Re: Louise P. Casias Residence, Sandalwood Subdivision
Grading and Drainage Plan
Engineer's Stamp dated 1-03-06 (J10-D16)

RE: REVISED DRAINAGE PLAN FOR SANDALWOOD SUBDIVISION (J10-D16)
REVISION DATED 2/5/96.

RE: REVISED DRAINAGE PLAN FOR SANDALWOOD SUBDIVISION
(J10-D16) REVISION DATED 1/3/96.

RE: DRAINAGE PLAN FOR SANDALWOOD SUBDIVISION (J10-D16)
ENGINEER'S STAMP DATED 12/04/95.

22-141 50 SHEETS
22-142 100 SHEETS
22-144 200 SHEETSEMERGENCY SPILLWAY
SECTION A-A

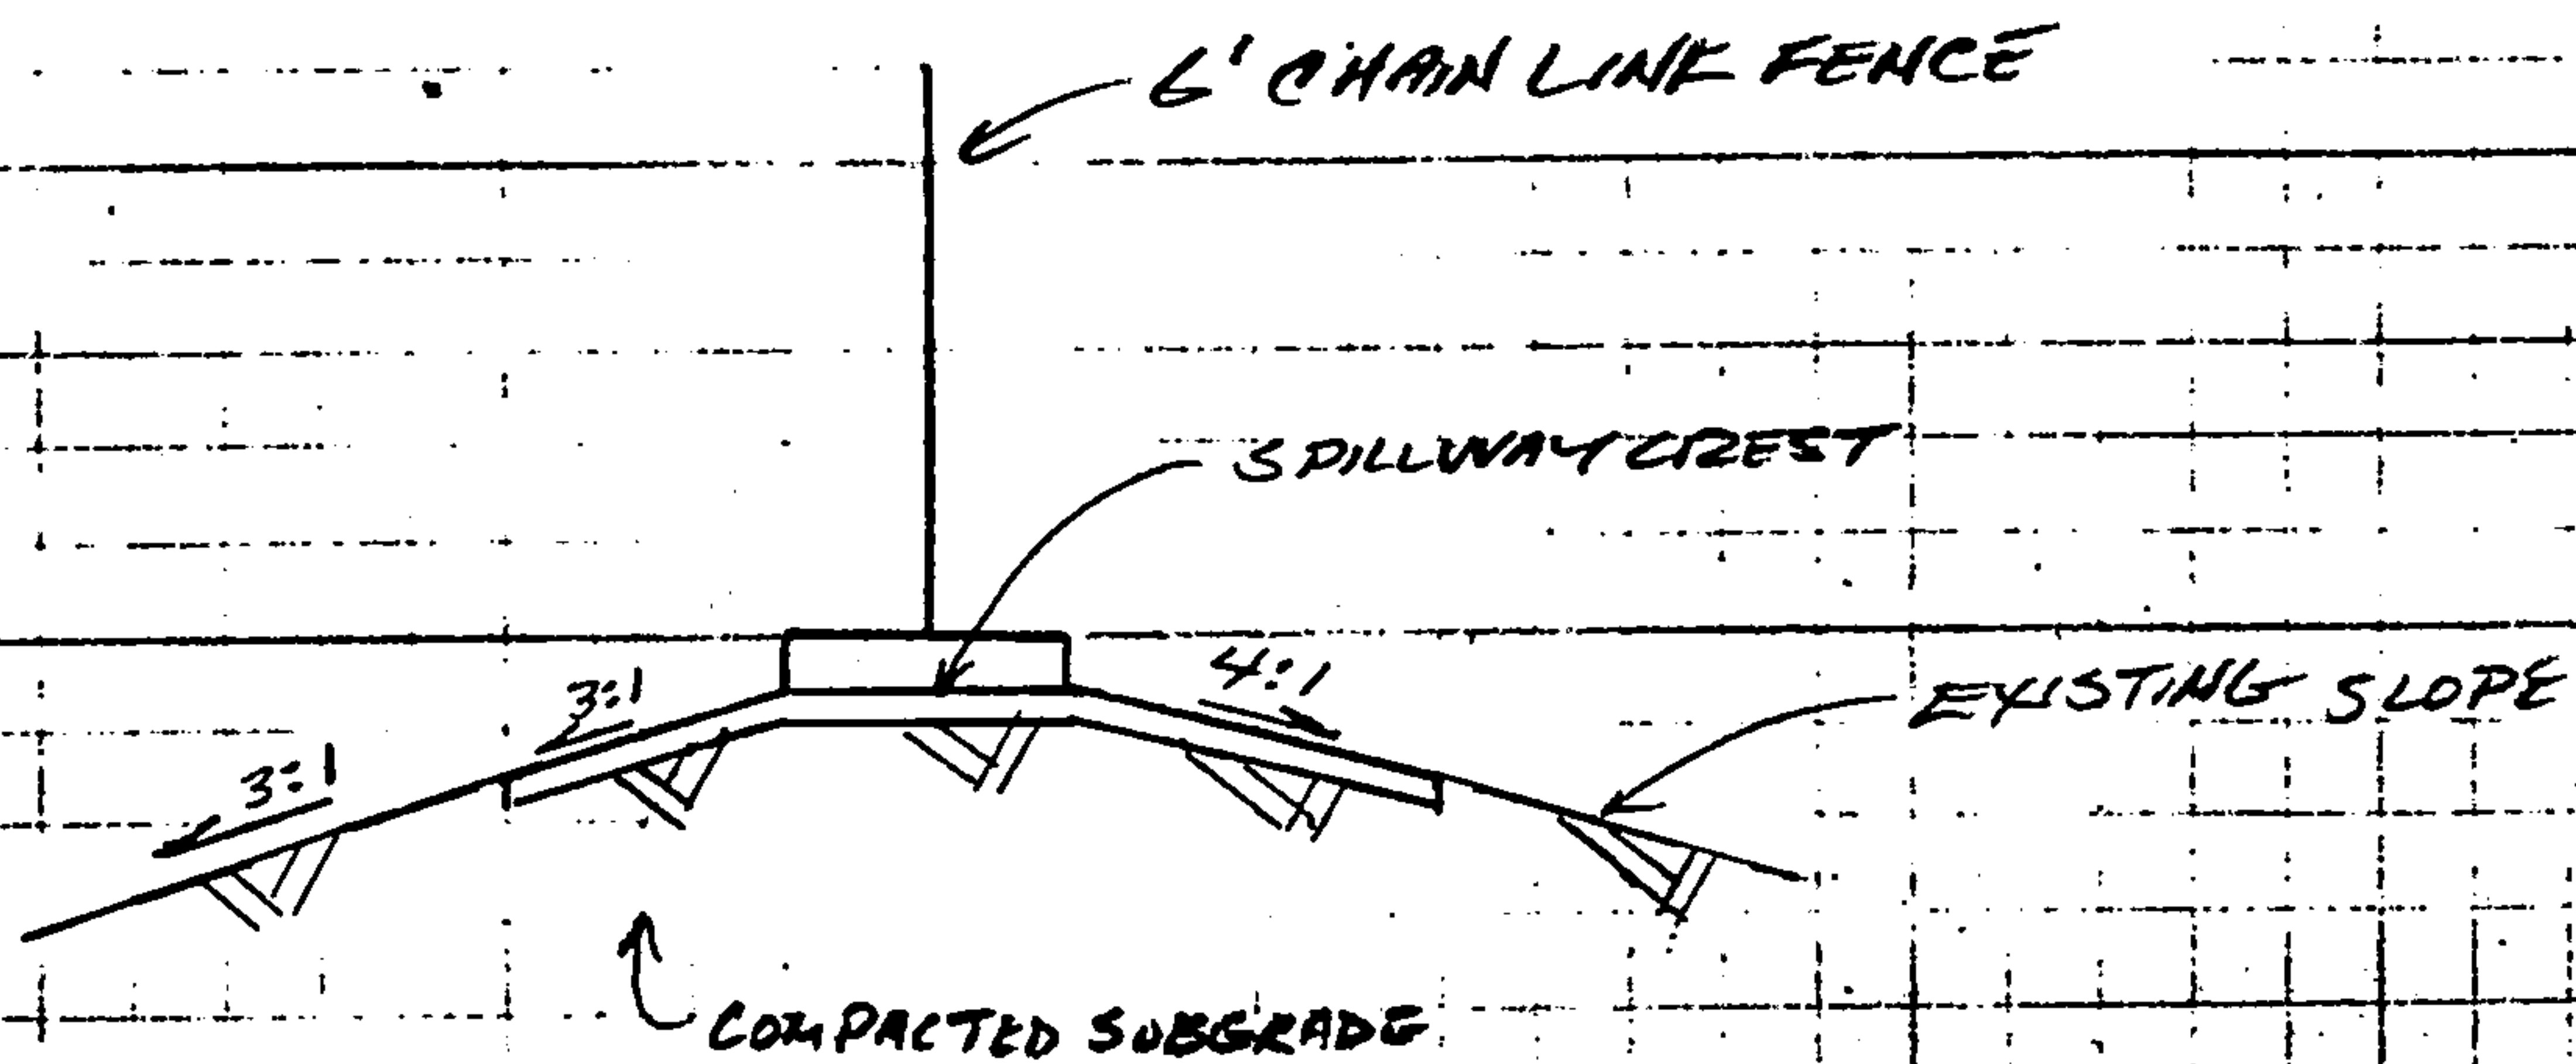
6. ✓ Please provide the computations for the emergency spillway requirements. Also, the spillway will need to be erosion and sediment proof.

EMERGENCY SPILLWAY DESIGN

DOUBLE "C" END OF ALWOOD DRIVE STA 0+73.38

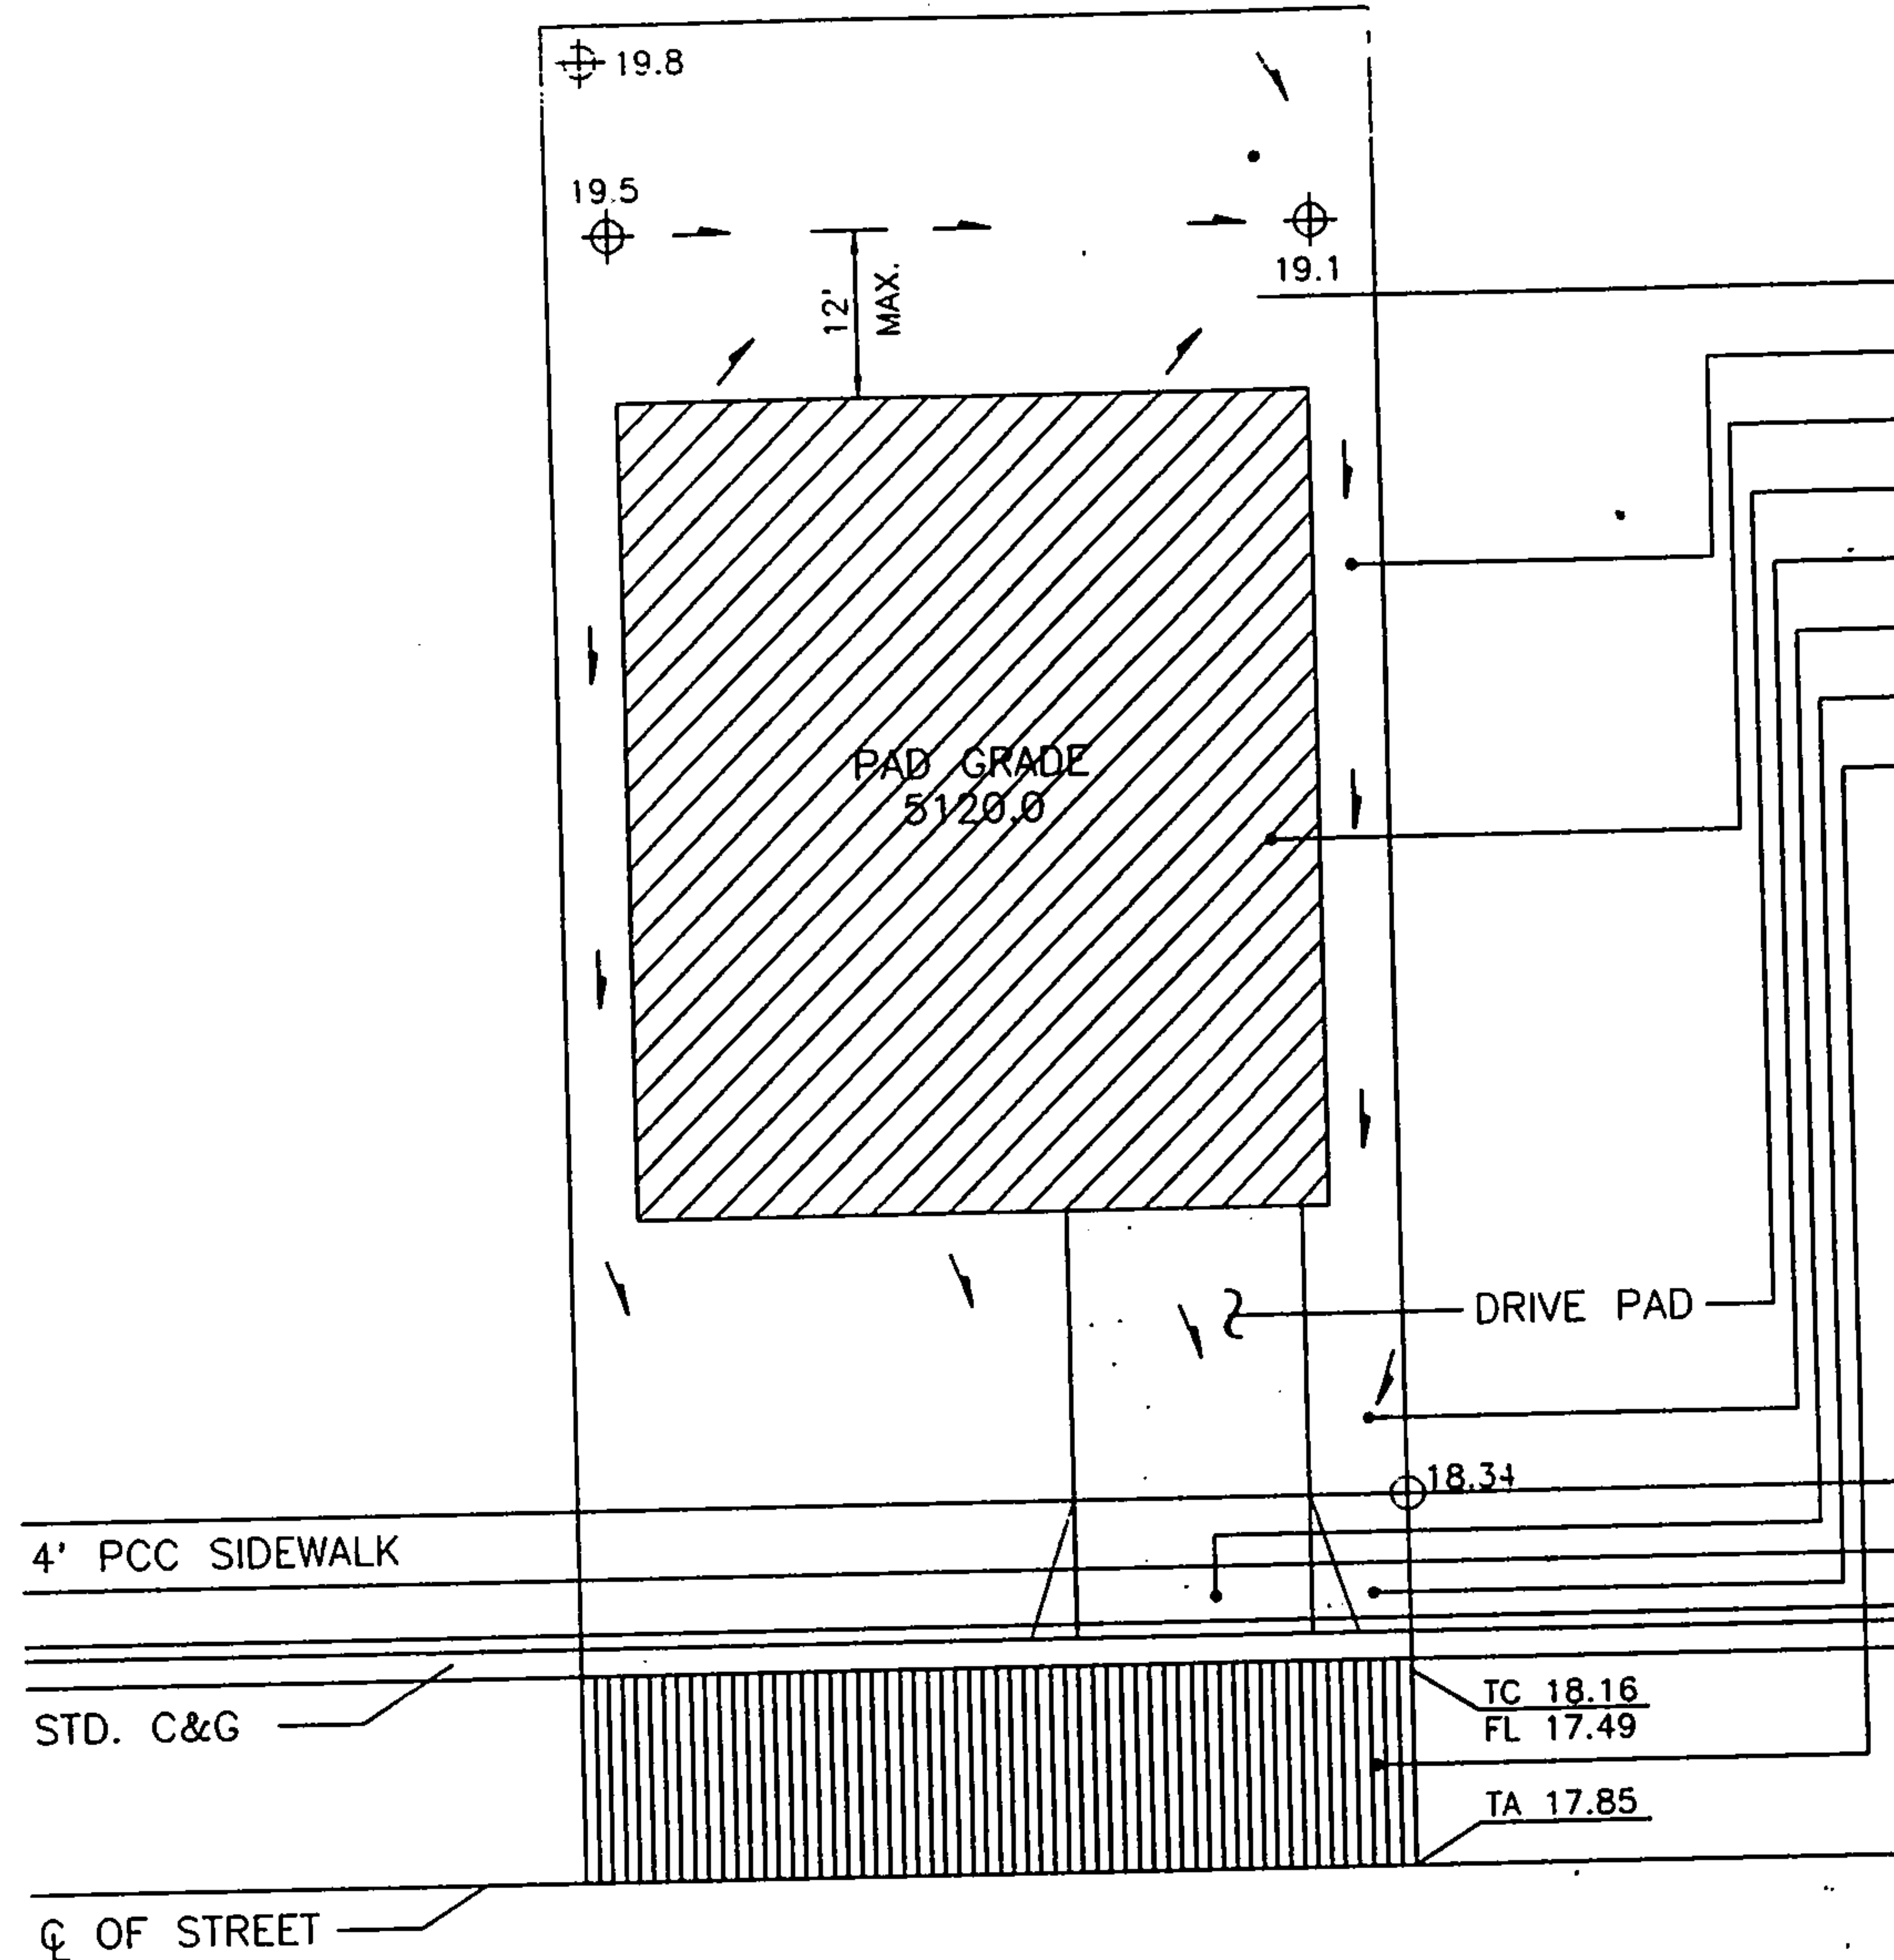
4. ? Please provide an off-site basin map indicating the off-site flows entering the site and how they will be accounted for.
5. Please provide the plates from the D.P.M. indicating the comparison between your HEC-2 and HY12 software results for the streets & inlets.

8" CURB AT TERMINUS PROVIDES PONDING

DEPTH = 0.67 ft

INTERIM STORM WATER RETENTION
POND

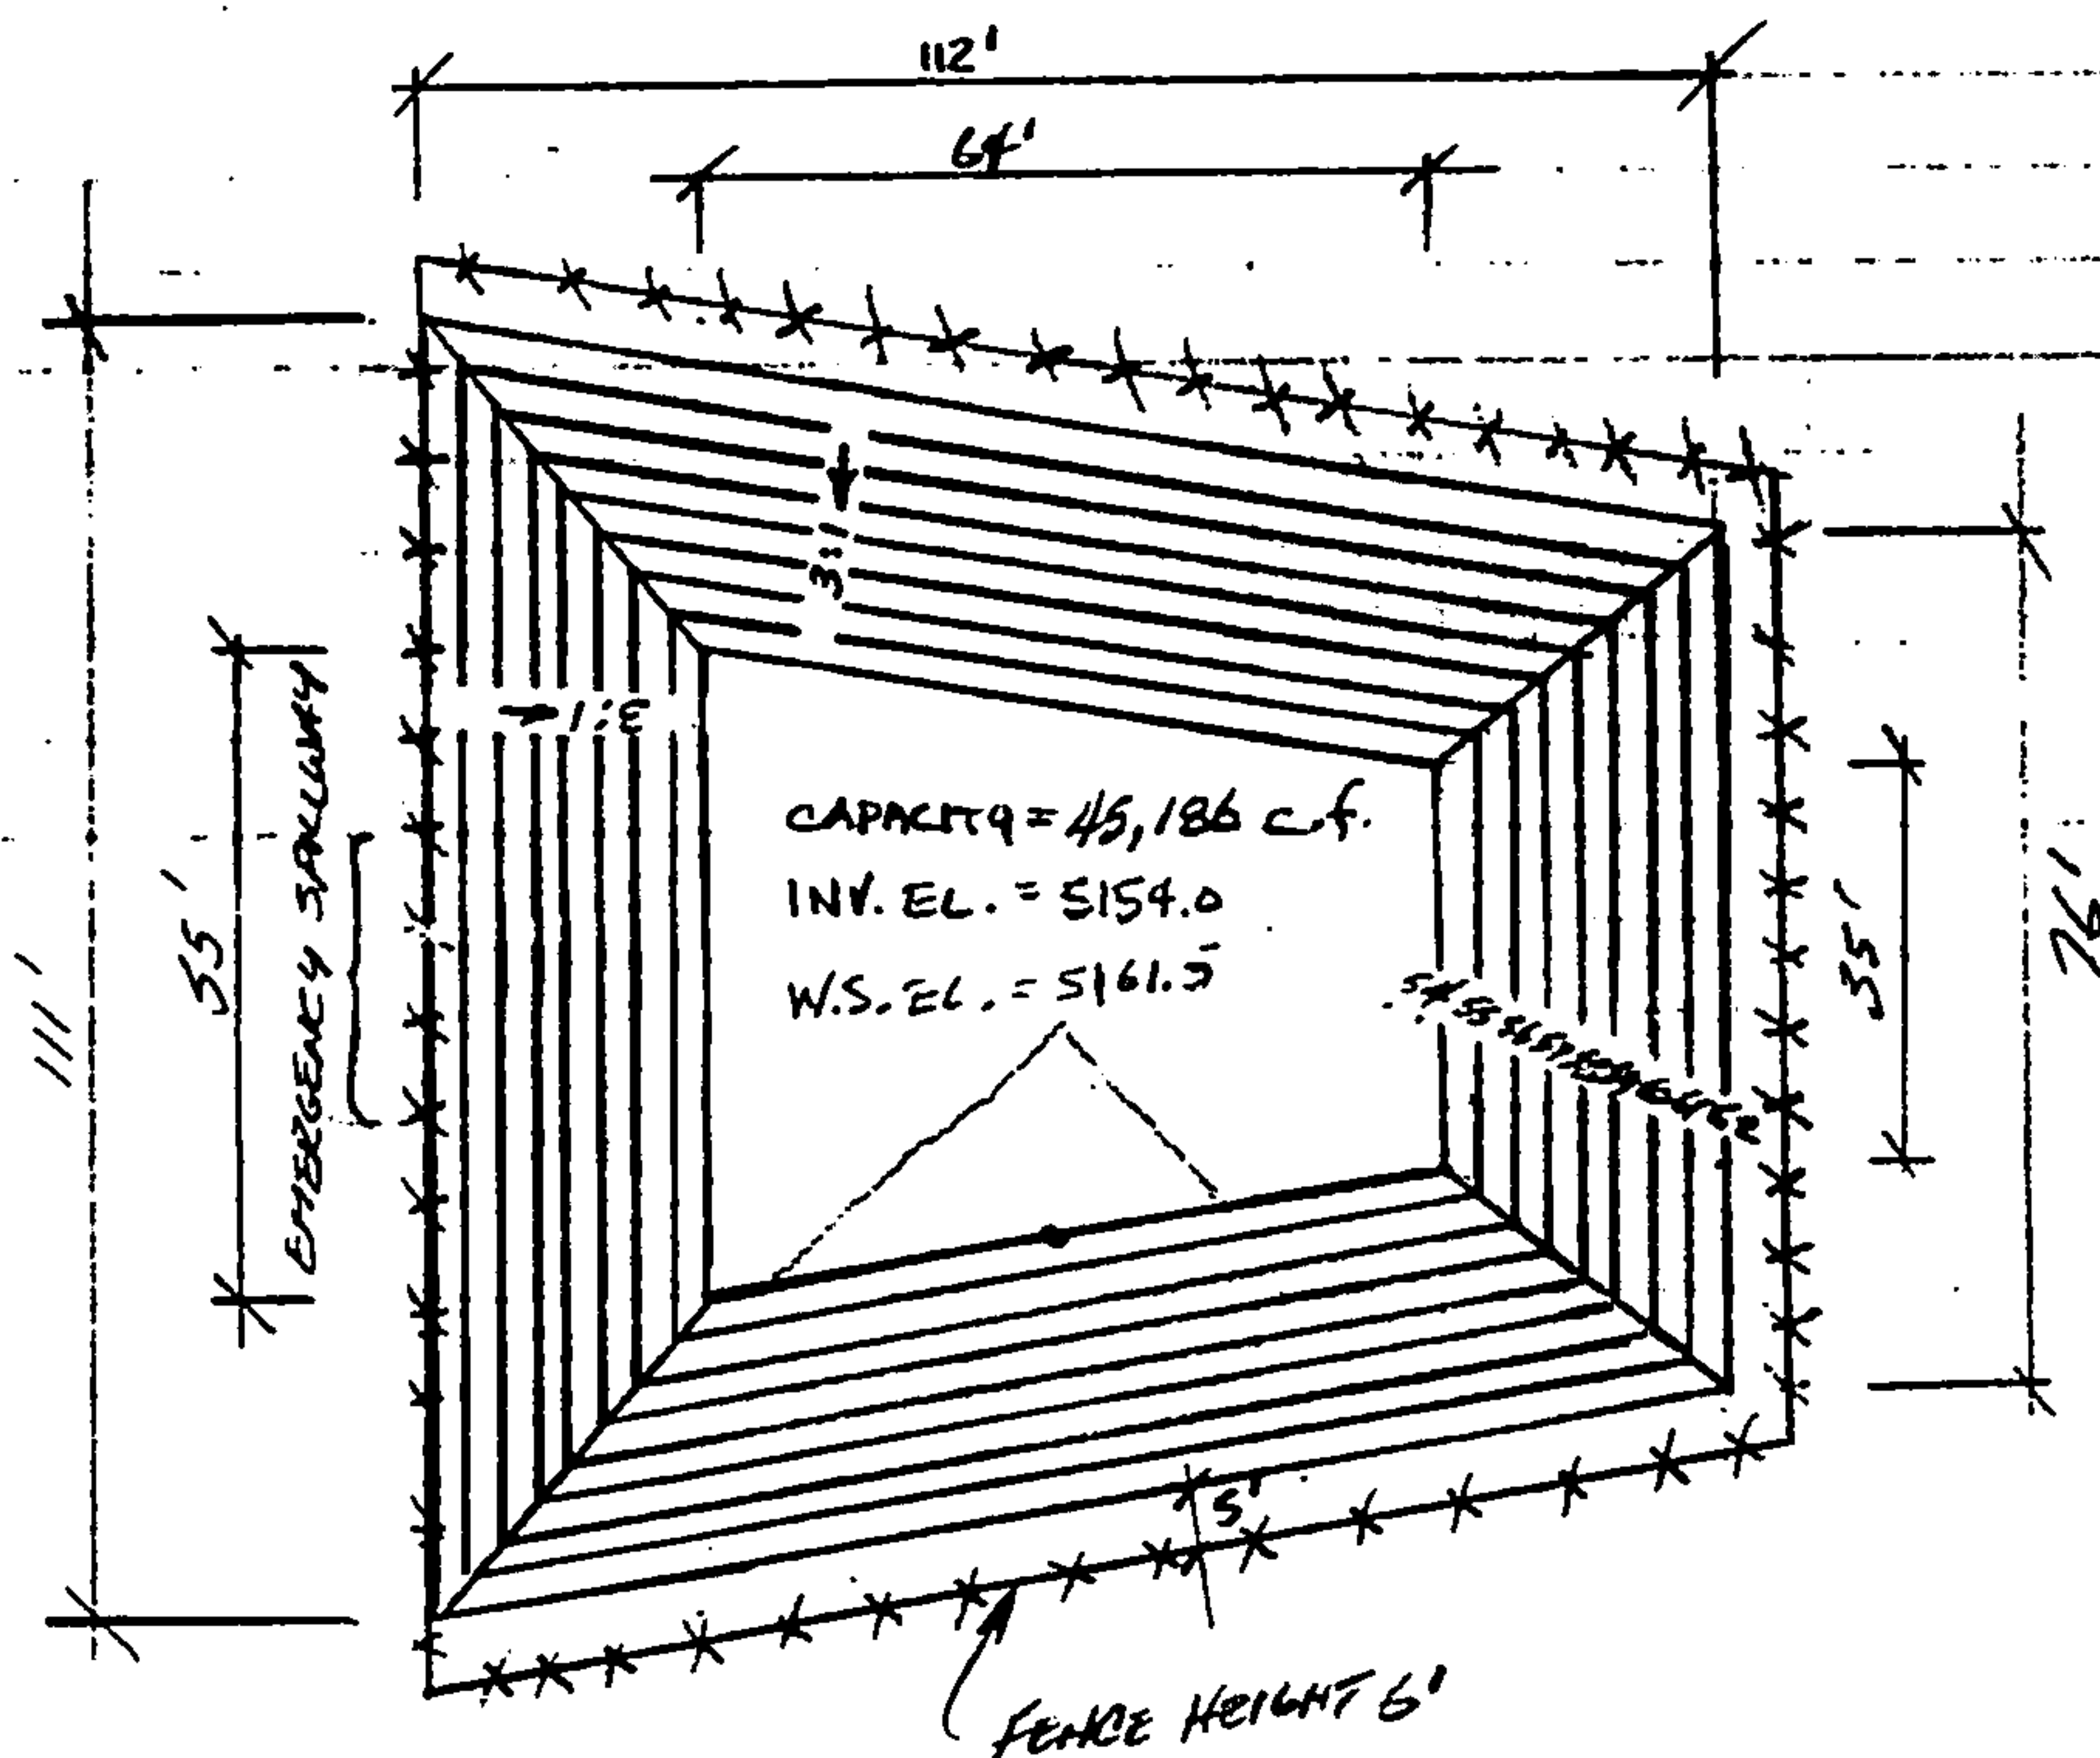
7. ✓ Typical detail showing the proposed ponding area. Please indicate the 100-year W.S.E. on the plan drawing. Also, indicate that fencing will be required on your narrative and what size.
8. ✓ Label Alwood Drive and Hanover Road on plan drawing.
9. ✓ Indicate the project T.B.M. on the plan drawing.
10. More spot elevations on the house footprint to identify that the developed run-off will all be routed to the street.

As you will note from the attached sketch, the capacity of the modified pond will be sufficient to intercept the runoff volume from the 100-year 6-hour storm. Three copies of the revised grading and drainage plan accompany this letter. We respectfully request your expedient review and approval of this document.
